Office Action Summary	Application No. 10/541,294	Applicant(s) MILLIKEN, JAMES M	
	Examiner Kristen C. Hayes	Art Unit 3643

DETAILED ACTION

**Modified Figure 5, US Patent 5,709,049****Modified Figure 12, US Patent 5,709,049**

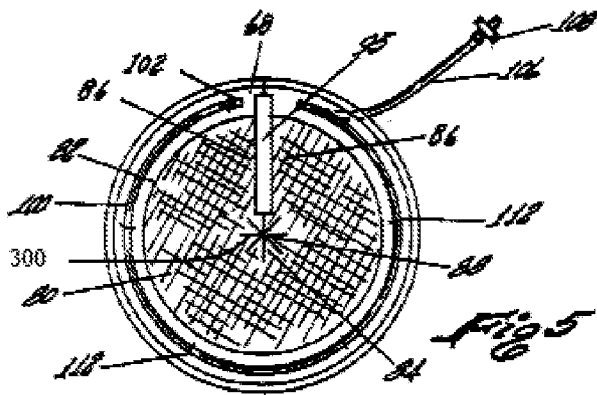
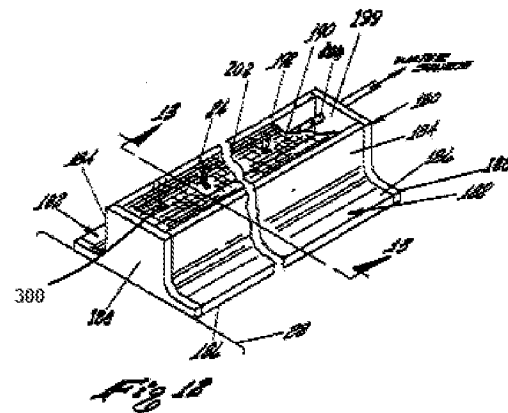
4. Regarding claim 16, Baird discloses a garden weed barrier and watering apparatus (20, 180) comprising landscape fabric (Baird, column 2: lines 1-2), having edge portions (42 or 184, 186) weighted to retain said fabric in a selected position upon the ground (Baird, column 2: lines 4-7), an opening (88 or 300) (Baird, column 7: lines 45-47) within said fabric for receiving garden plants (24), and a water-permeable tube (100 or 200) (Baird, column 5: lines 17-18) attached to the underside of said fabric adjacent an edge of the opening (Baird, Figures 5, 12).

5. Regarding claim 17, Baird discloses a device with the limitations of claim 16 further characterized by the tube (100 or 200) having segments thereof attached in close proximity to corresponding openings (Baird, Figure: 12).

6. Regarding claim 19, Baird discloses a device with the limitations of claim 19 further characterized by the openings (88 or 301) being partially defined by respective portions of the tube (100 or 200) (Baird, Figure: 5).
